# Request for Class II Permissive Change

FCC ID: **YZZGXP1400** Data: September 19<sup>th</sup>, 2014

### New PoE module photo view

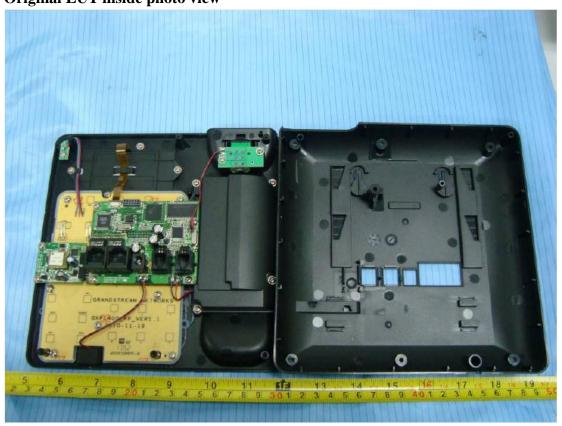
- 1. Upgraded PoE module hardware version from GXP1405\_PoE\_ V1.4A to GXP1405\_PoE\_ V2.0A;
- 2. Changed component layout& PCB layout of PoE module (pls see arrow 1);
- 3. Changed internet chip version from KSZ8873RLL to KSZ8863(pls see arrow 2)
- 4. Added two power adapter(pls see test report page 4 of 45)
